Docket Number:	23-AFC-02
Project Title:	Elmore North Geothermal Project (ENGP)
TN #:	250678
Document Title:	BHER ENGP 23-AFC-02 DA Supplement Set 2 06-20-23
Description:	BHER ENGP 23-AFC-02 DA Supplement Set 2, AQ, BIO, and NOISE
Filer:	Sarah Madams
Organization:	Jacobs
Submitter Role:	Applicant Consultant
Submission Date:	6/20/2023 11:45:13 AM
Docketed Date:	6/20/2023

Data Adequacy Supplement Set 2

Elmore North Geothermal Project
(23-AFC-02)
June 20, 2023

Figure DA 5.2-1b
Biological Study Area
Elmore North Geothermal Project
 Imperial County, California

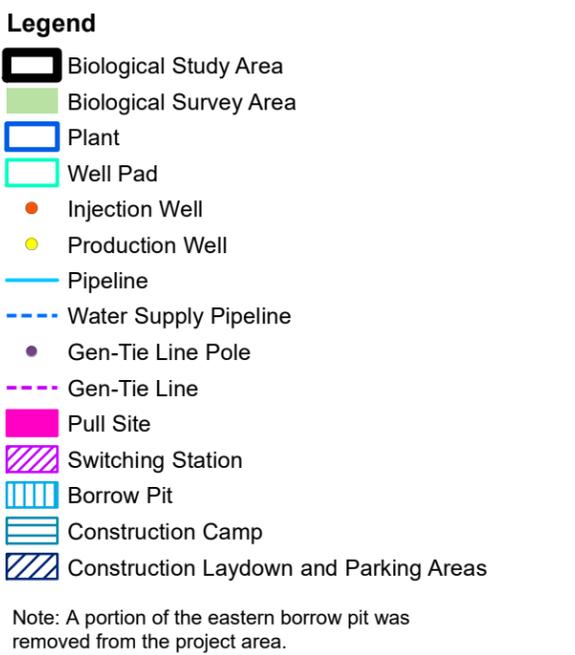
Alamo River: These sections provide a further discussion of the Alamo River. Figure DA 5.2-1 shows the location of Alamo River in proximity to ENGP (Appendix DA 5.2-1b). The Alamo River flows northwest through the middle of ENGP BSA and discharges into the Salton Sea (Figure DA 5.2-1). The Alamo River is impacted by "...urban and agricultural runoff, pollution, sedimentation, trash, and invasive species, rarely functioning as naturally flowing river. Much of the floodways...are populated with high-density invasive plant species including salt cedar...[and] giant reed. These species provide low habitat value for listed wildlife species, reduce water availability, increase fire risk in riparian zones, alter soil chemistry, and increase flood risk." (CNRA 2023). In the Project vicinity, the Alamo River was on average 50 feet across. No ENGP features cross the Alamo River. Three temporary disturbance areas are approximately 1,000 feet from the Alamo River (Figure DA 5.2-1) and do not impact any riparian vegetation, woodland, or shrubland associated with the Alamo River.
